# 1955 Corvette: Service Bulletin: Hard Shifting

<b>CHEVROLET—CENTRAL OFFICE</b> DIVISION OF GENERAL MOTORS CORPORATION DETROIT 2, MICHIGAN	
<b>TECHNICAL SERVICE BULLETIN</b> Service and Mechanical Department	
<b>SUBJECT:</b> HARD SHIFTING - 1955 MODEL PASSENGER CAR 3-SPEED TRANSMISSION	<b>BULLETIN No.</b> DR #236
<b>TO:</b> ALL CHEVROLET DEALERS	<b>SECTION</b> VII January 9, 1956
<p>In cases where hard shifting on 1955 Passenger Models with 3-Speed Transmission is experienced in high frequency shifting operations due to malfunction and/or wear of gearshift controls and butting of transmission gears, the condition may be reduced by installation of a Transmission Control Conversion Kit and three new type transmission gears.</p> <p>The new transmission gears which have more tooth chamfer entered production about July 5, 1955.</p> <p>The revised transmission controls entered production beginning with 1956 Model and the Control Conversion Kit has modified parts for use on 1955 Models.</p>

FIGURE I

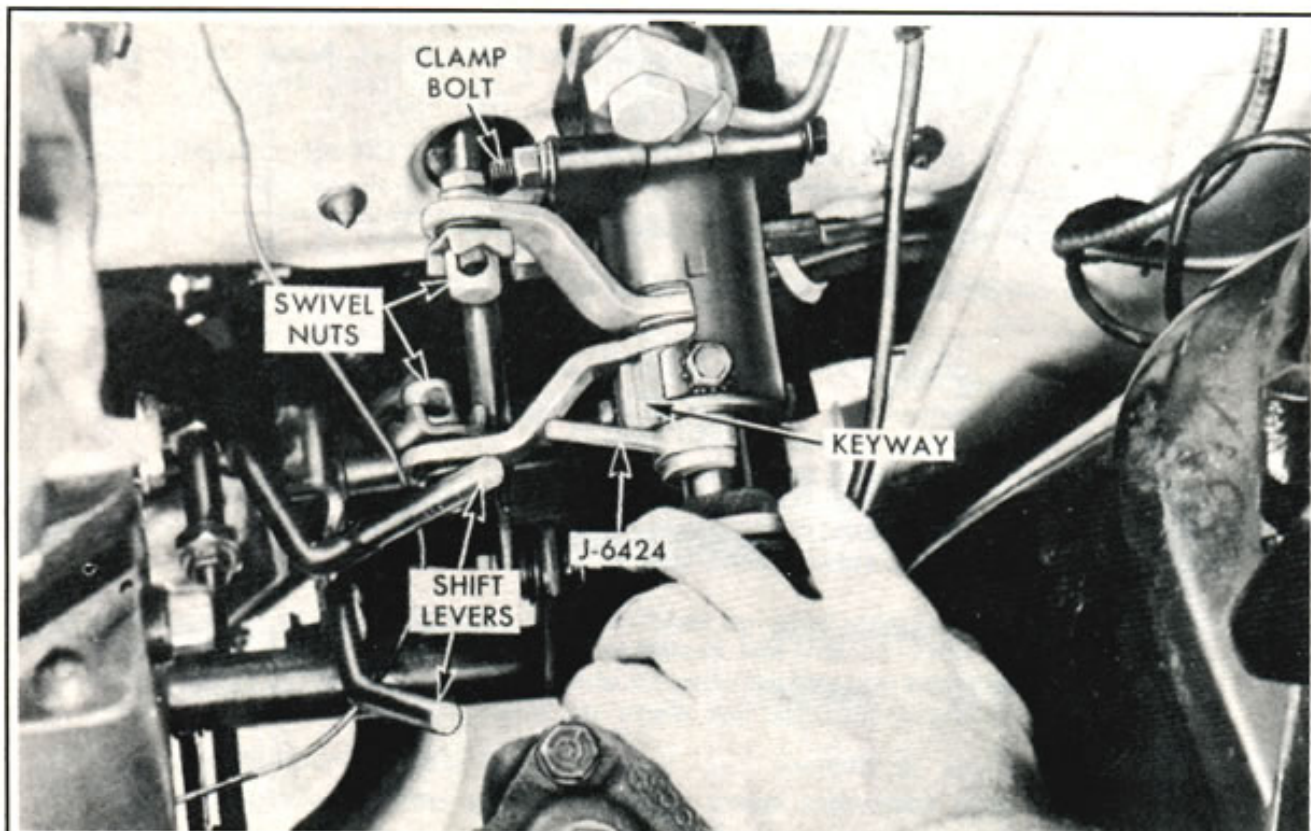
13. Insert gearshift rod ends in swivels - transmission must be in neutral detent in both ranges. Do not tighten.
14. Install alignment gauge J-6424 inserting side stamped "STD" between steering mainshaft and shifter tube in key area. This sets the required 1/16 eccentricity in proper relation to the key on shifter tube. See figure 1.

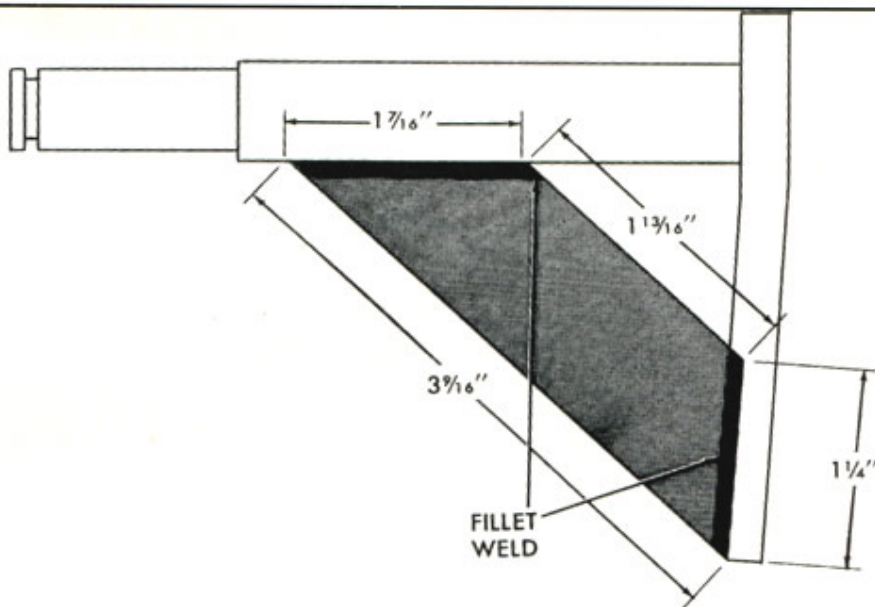
- c. Remove alignment gauge.
16. Make and insert special blade gauge, see figure 2, thru adjusting ring slot, lower levers and gate washer. Tighten swivels on gearshift rods while holding downward lightly on lower levers. Transmission must be in neutral detent at this time.

FIGURE 3

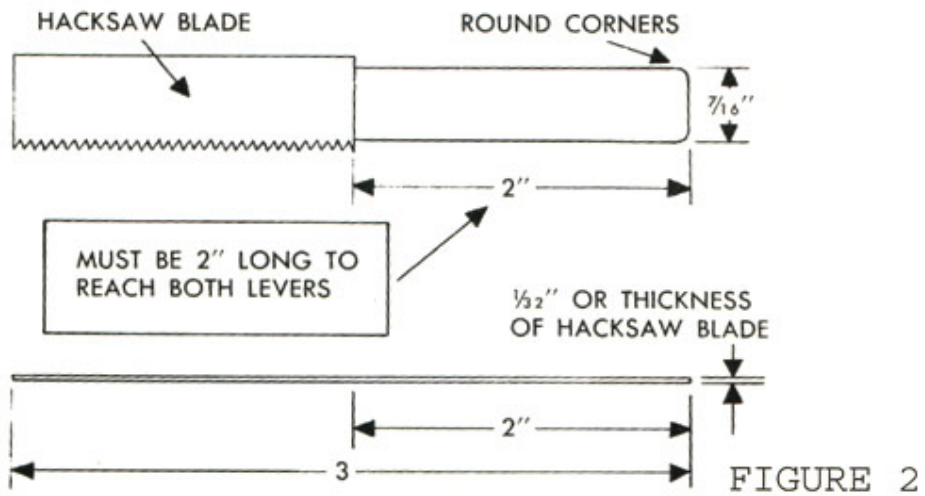
Further improvement of shifting can be made by reinforcement of transmission control rod idler lever support located on left frame rail under toe pan to reduce its deflection. See figure 3.
